Drainage Letter

**Viewpoint Estates
Filing No. 2**

Project No. 61099

PCD File No. SP-21-005 & SF-21-042

EXISTING DRAINAGE MAP

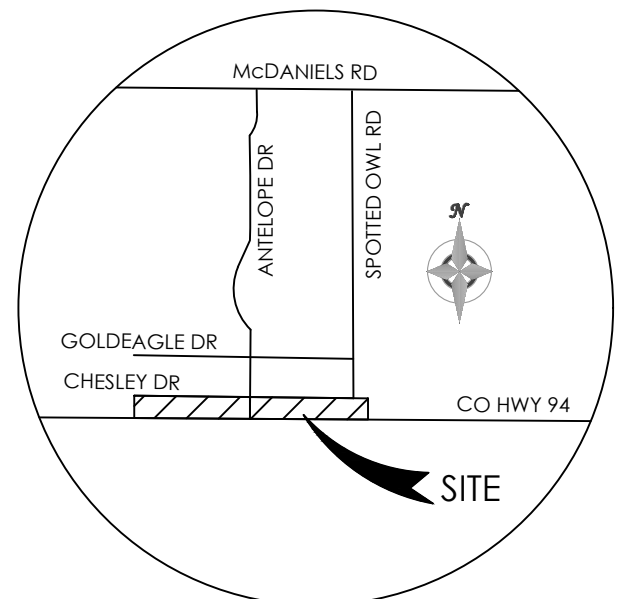
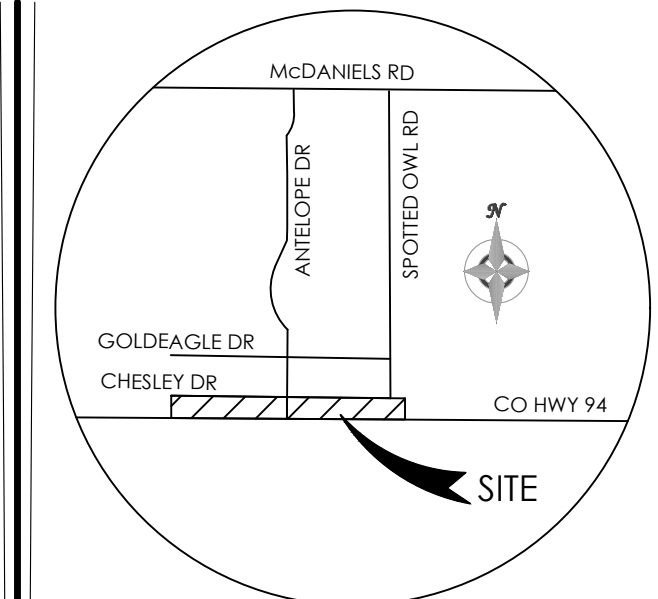
Move callout so it isn't obstructed.

Show off-site watersheds that contribute to DP1, DP5
Show to paths
